HARTZELL PROPELLER INC.

ALERT SERVICE BULLETIN

HC-ASB-61-405

109438 Beta Rod Support Ring

**Centrifugal Force on Beta Rods
Figure 1**

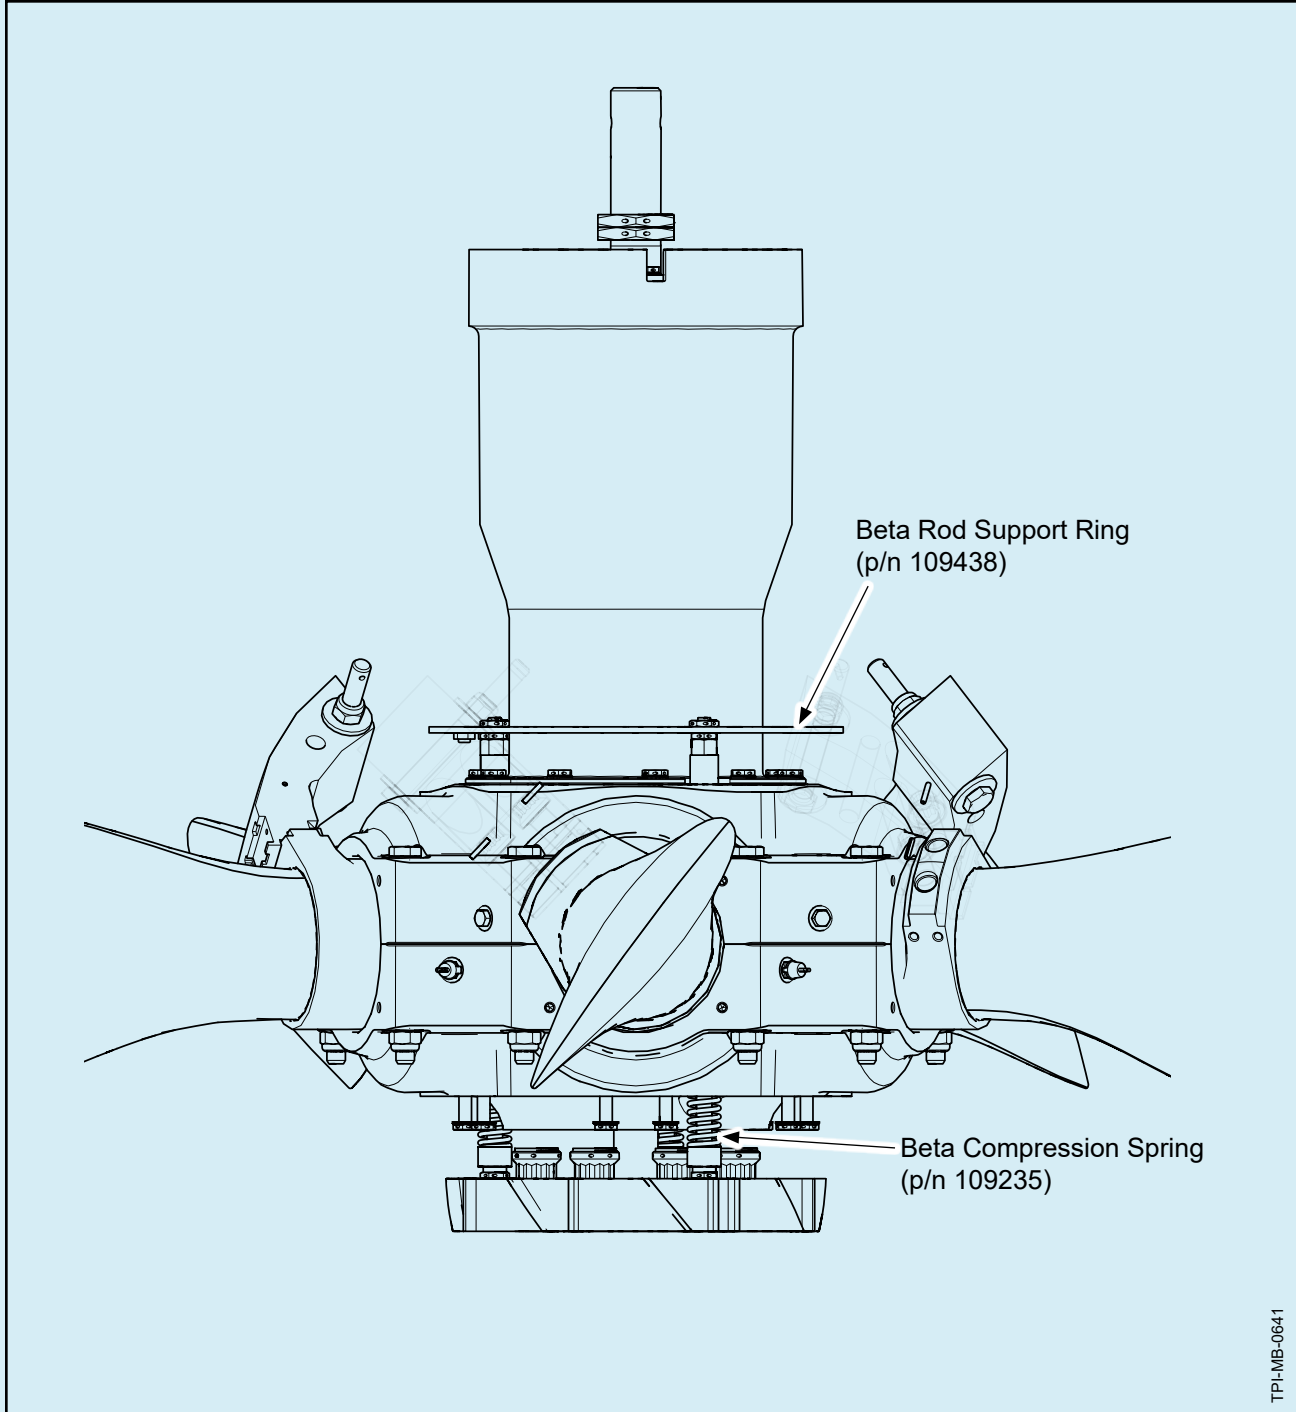
- (1) During operation, centrifugal force on the 107372 beta rods can create friction that affects the response of the electronic beta system used on the affected propellers.
 - (a) Centrifugal force causes the top (cylinder-end) of the 107372 beta rods to move outward, creating friction against the B-457 beta sleeves as the beta rods move. Refer to Figure 1.
- (2) Hartzell Propeller Inc. is introducing a design change to reduce friction and increase the return spring force of the electronic beta system used on the affected propellers. Refer to Figure 2.
 - (a) The new design incorporates a beta rod support ring (p/n 109438) to prevent outward movement of the beta rods at the cylinder-end, stronger compression springs (p/n 109235) for increased return force, and a redesigned spring guide sleeve (p/n A-466-1, Rev. I) with a smaller OD to reduce friction.

**Beta System Component Removal
Figure 3**

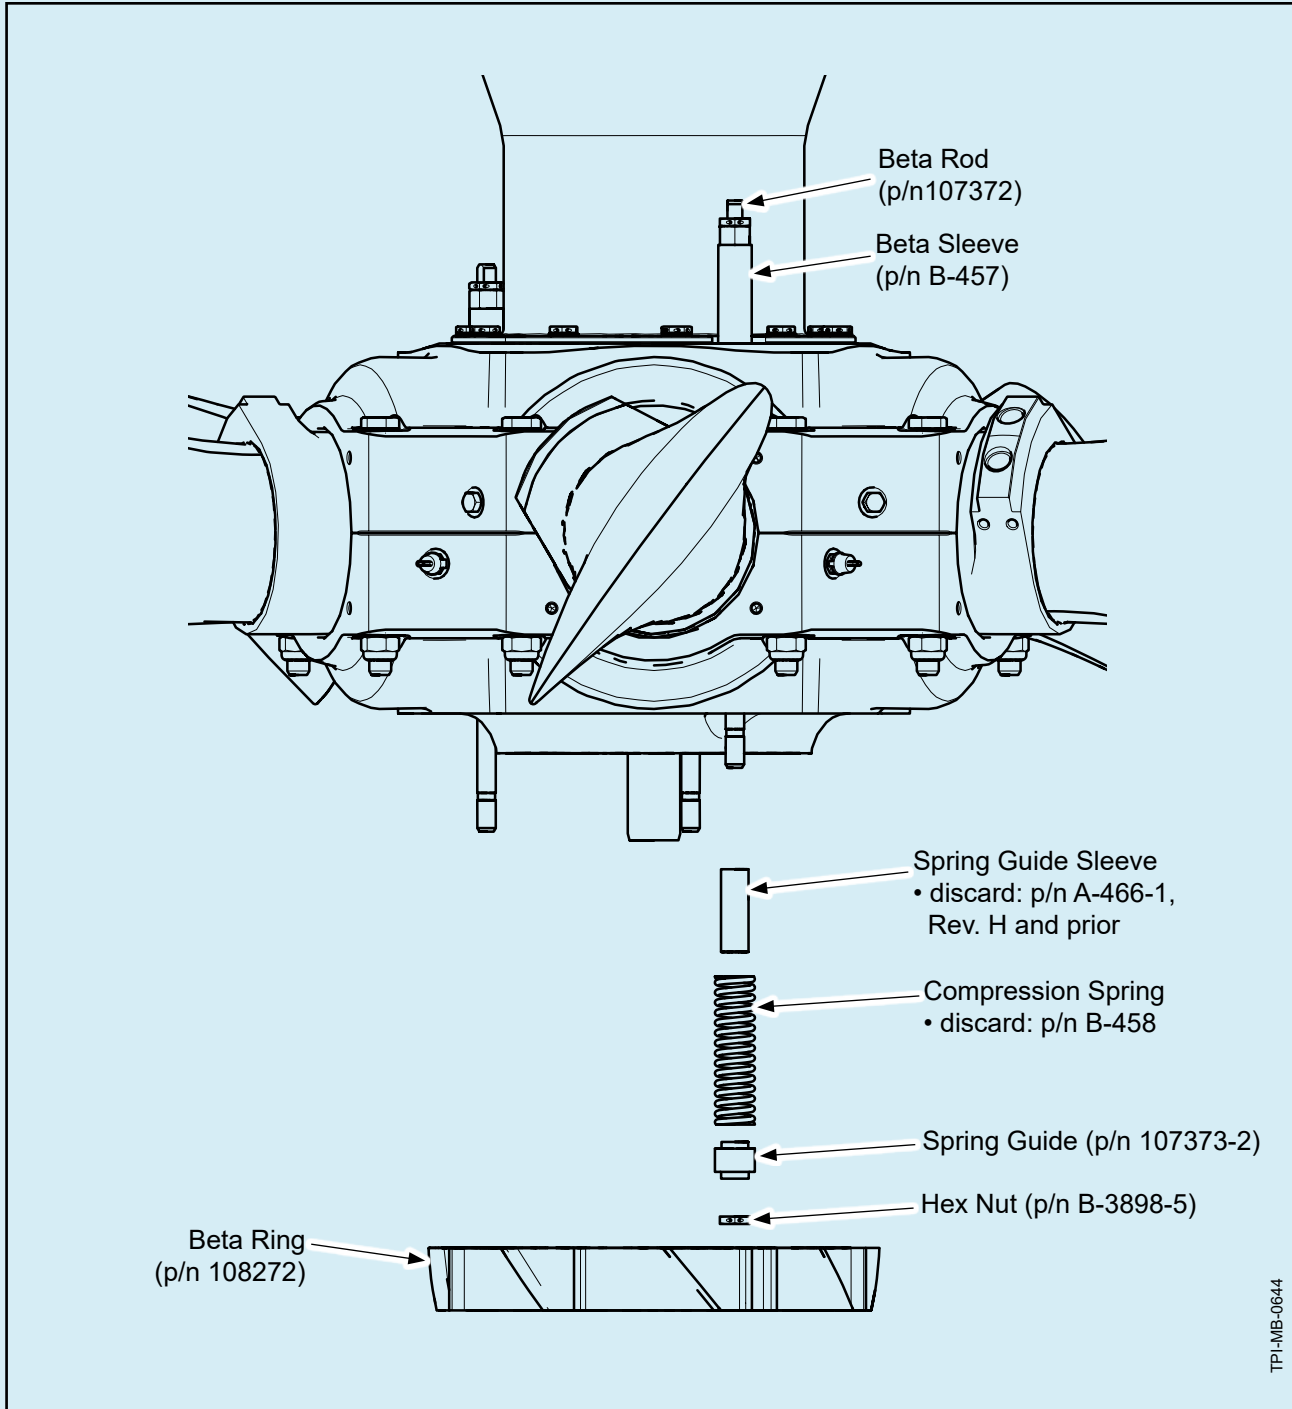
(4) Remove the beta system components in accordance with Figure 3 and the following steps:

- (a) Using a 1/4 inch open-end wrench on the flats at the cylinder-end of the beta rods (p/n 107372), hold the rods in place then loosen the three hex nuts (p/n B-3898-5).

- (b) Using a 1/4 inch open-end wrench on the flats on the cylinder-end of the beta rods (p/n 107372), turn the beta rods out of the beta ring (p/n 108272).
- (c) Remove the beta ring from the beta rods.
- (d) Remove the three hex nuts (p/n B-3898-5) and three spring guides (p/n 107373-2).
- 1 Optionally, use the spring installation tool TE658 to compress the compression springs (p/n B-458) before removing the hex nuts (p/n B-3898-5). Refer to the section, "Using the Spring Installation Tool" Hartzell Propeller Inc. Raptor Series Turbine Propeller Overhaul Manual 496 (61-10-96).
- (e) Remove and discard the three compression springs (p/n B-458) and the three spring guide sleeves (p/n A-466-1).
- (f) Remove the three beta rods and beta sleeves (p/n B-457) from the hub assembly.
- 1 Using solvent CM106 MEK or CM219 MPK, clean the beta rods and beta sleeves.

**Cylinder/Pitch Change Rod Removal
Figure 4**

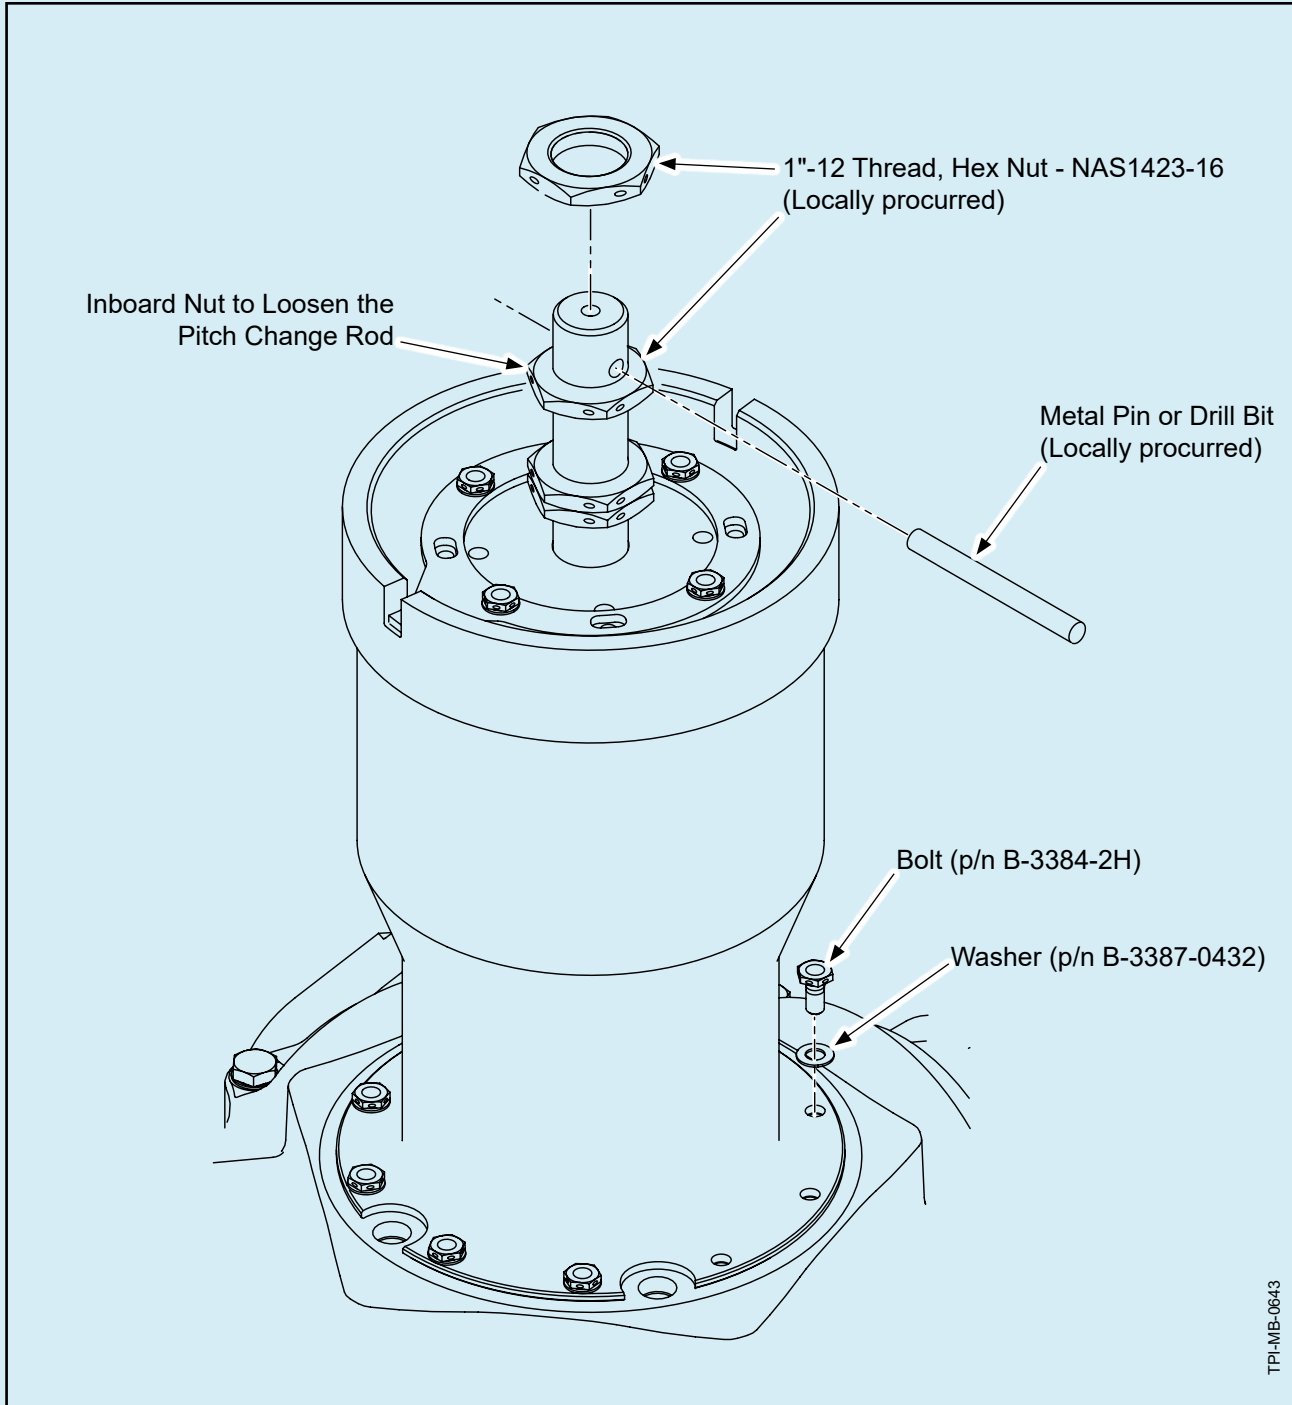
- (5) Remove the cylinder/pitch change rod assembly in accordance with Figure 4 and the following steps:
 - (a) Thread one 1"-12 thread hex nut onto the pitch change rod until it is below the hole in the pitch change rod.

- (b) Insert a metal pin or drill bit through the hole in the pitch change rod.
 - (c) Thread another 1"-12 thread hex nut onto the pitch change rod until it contacts the metal pin or drill bit

- (d) Remove the bolts (p/n B-3384-2H) and washers (p/n B-3837-0432).
 - (e) Use a wrench on the inboard hex nut installed in step 5.(a) to loosen the pitch change rod from the fork.

- (f) Turn the cylinder (by hand) to unthread the pitch change rod from the fork.
 - (g) Carefully remove the pitch change rod/cylinder assembly.
 - 1 Clean the threads of the pitch change rod to remove anti-sieze compound.

- (h) Remove and discard the cylinder mounting O-ring (p/n C-3317-050) from the hub.

Cylinder/Pitch Change Rod Installation
Figure 5, page 1 of 2

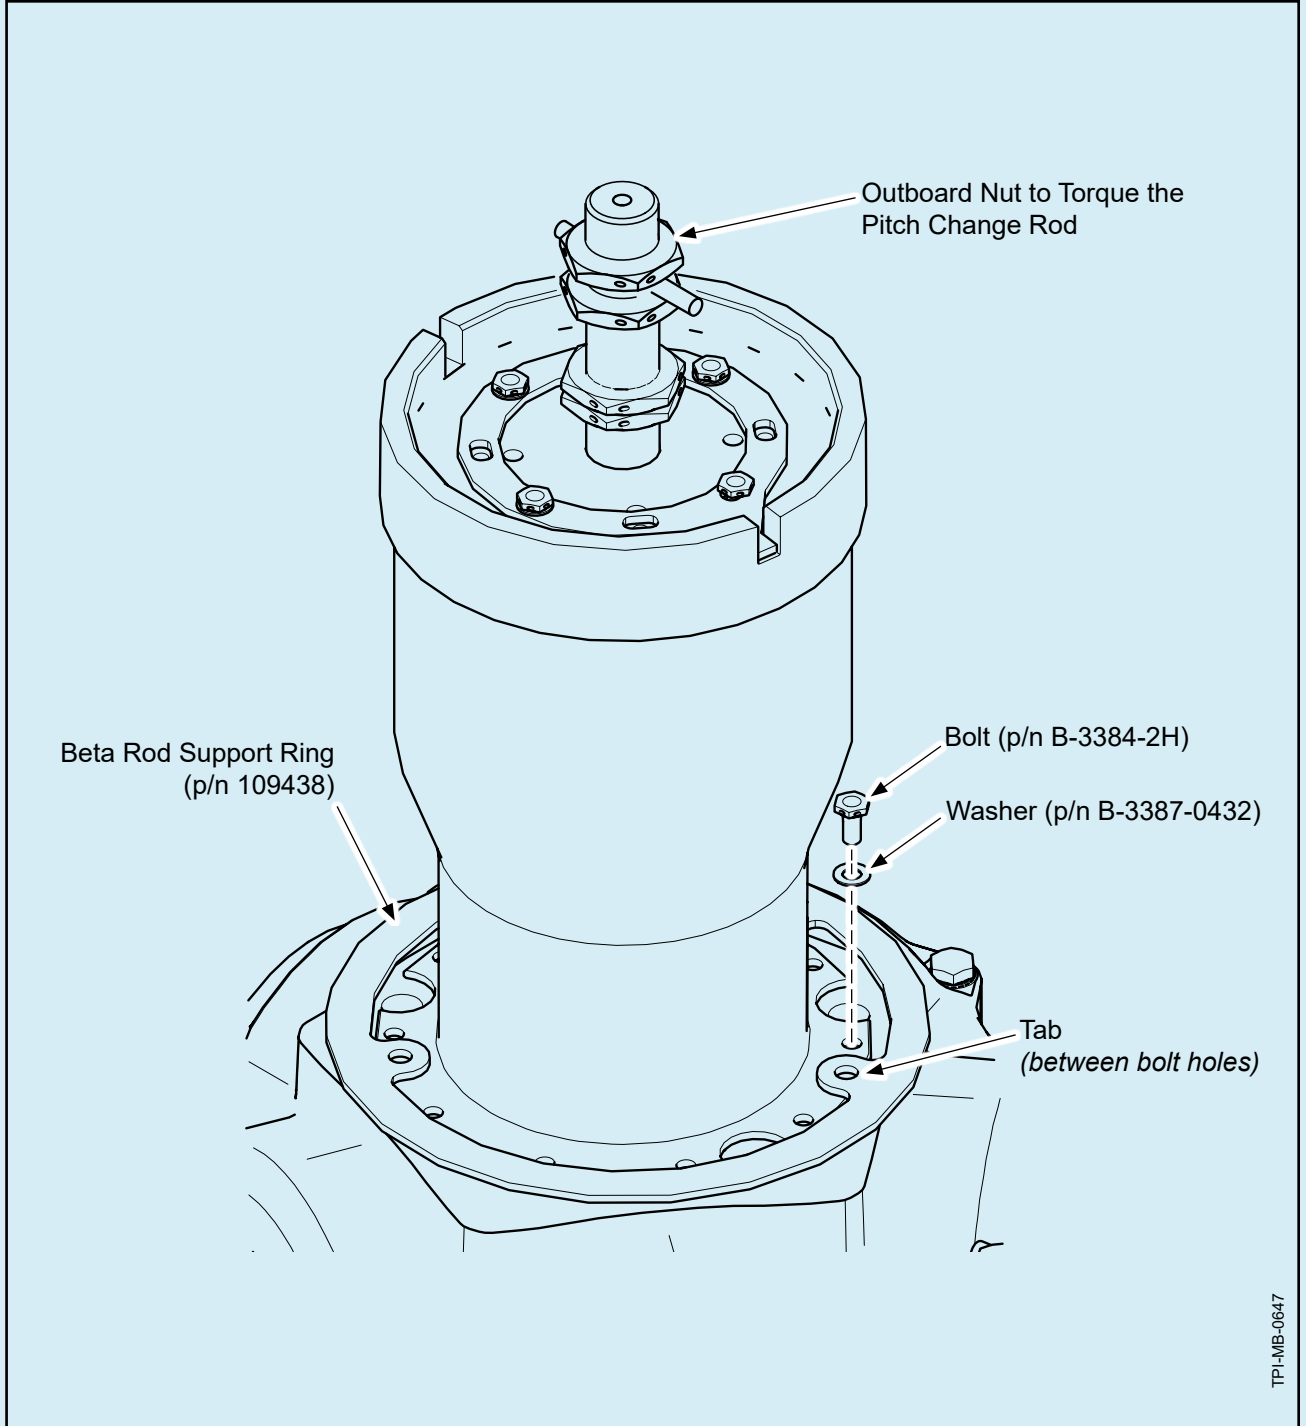
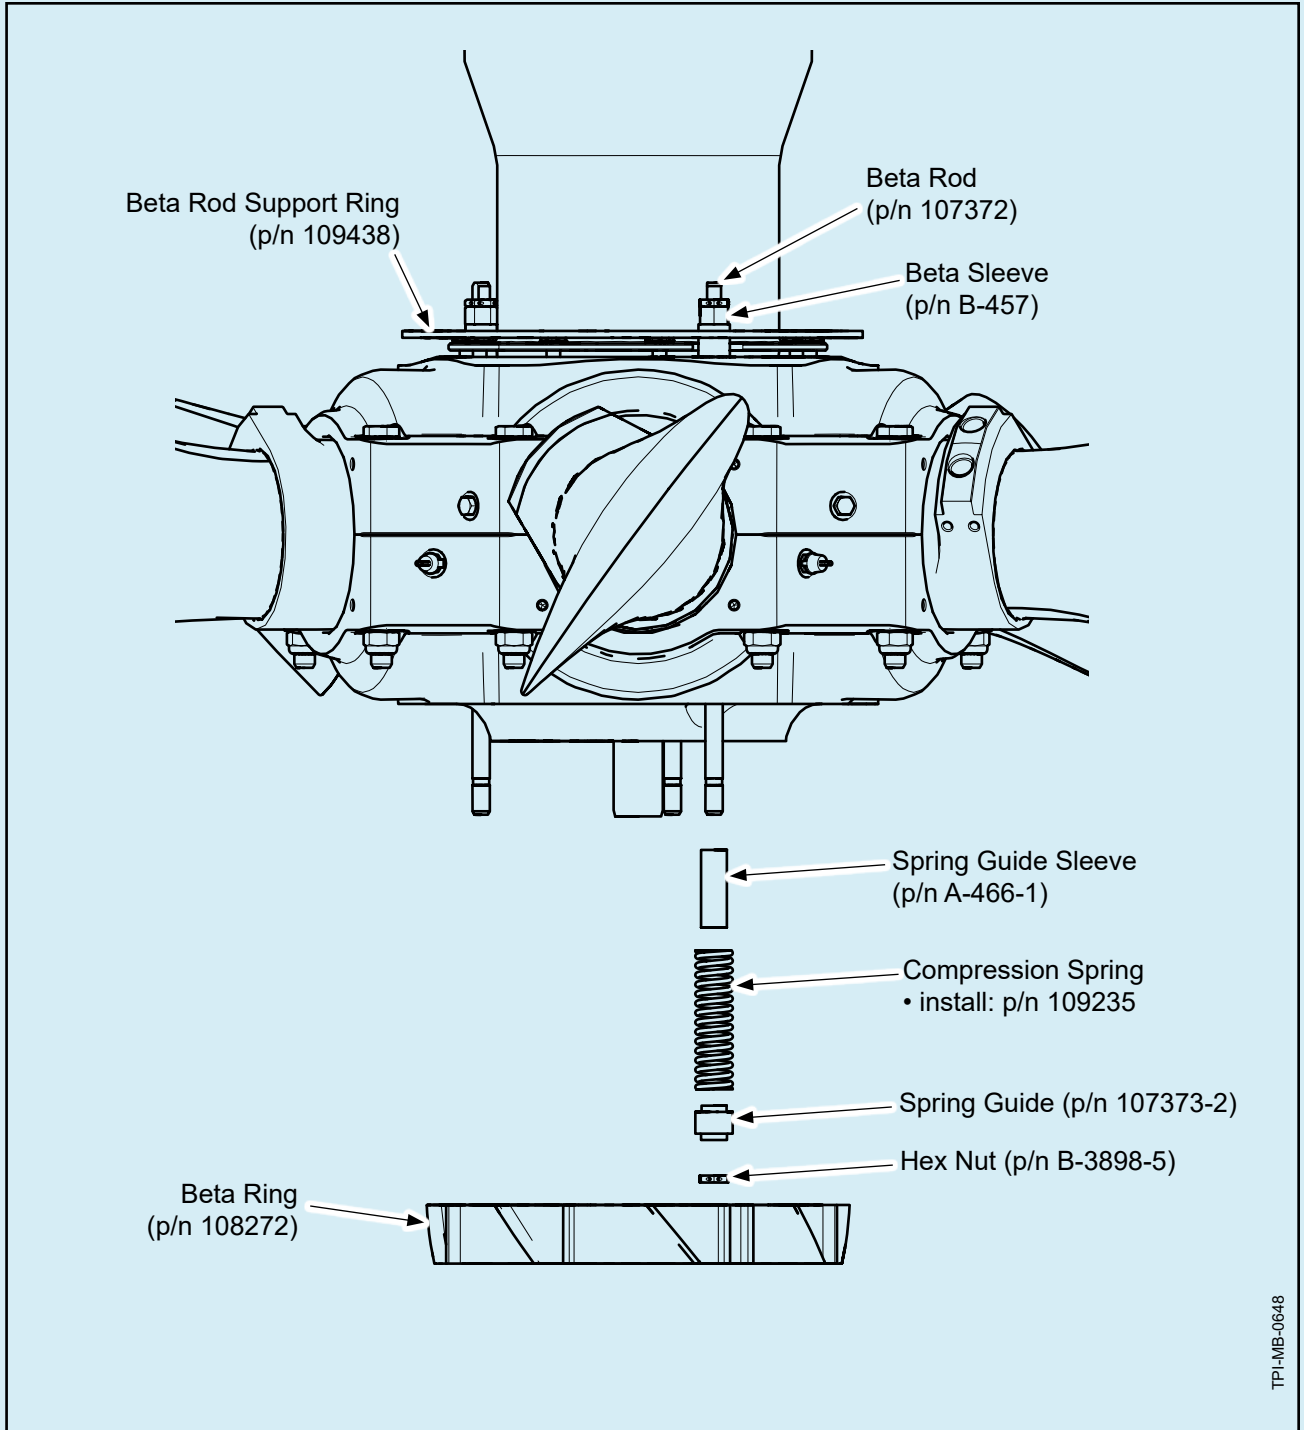
- (6) Install the beta rod support ring (p/n 109438) and the pitch change rod/cylinder assembly in accordance with Figure 5 and the following steps:
 - (a) Apply NYCO grease CM12 to the cylinder mounting O-ring (p/n C-3317-050), then install the O-ring in the cylinder-side of the hub.

- (b) Place the beta rod support ring (p/n 109438) on top of the hub.
 - (c) Apply anti-seize compound CM118 to the external threads adjacent to the tapered section of the pitch change rod.

- (d) Install the pitch change rod/cylinder assembly, carefully aligning the pitch change rod with the hole in the fork and the engine-side hub bushing.

- 1 Turn the cylinder (by hand) to thread the pitch change rod into the fork.
 - (e) Rotate the beta rod support ring (p/n 109438) to align the tabs with the cutouts in the cylinder flange, then lift and rotate the beta rod support ring so that it is on top of the cylinder flange.

- 1 Position the tabs of the beta rod support ring between bolt holes in the cylinder flange.
 - (f) Use a wrench on the outboard hex nut installed during cylinder removal to torque the pitch change rod to 72-88 Ft-Lbs (98-119 N•m).

- 1 Remove the metal pin/drill bit and the two locally procured hex nuts installed to loosen/tighten the pitch change rod into the fork.
 - (g) Use a strap wrench TE148-1 or equivalent, turn the cylinder to align the cutouts in the cylinder flange with the beta rod holes in the hub.

- (h) Install ten hex bolts (p/n B-3384-2H) and ten washers (p/n B-3837-0432).
 - 1 Torque the hex bolts (p/n B-3384-2H) to 12-14 Ft-Lbs (17-19 N•m).
 - (i) Rotate the beta rod support ring (p/n 109438) to align the tabs with the cutouts in the cylinder flange, then safety wire the ten hex bolts (p/n B-3384-2H).
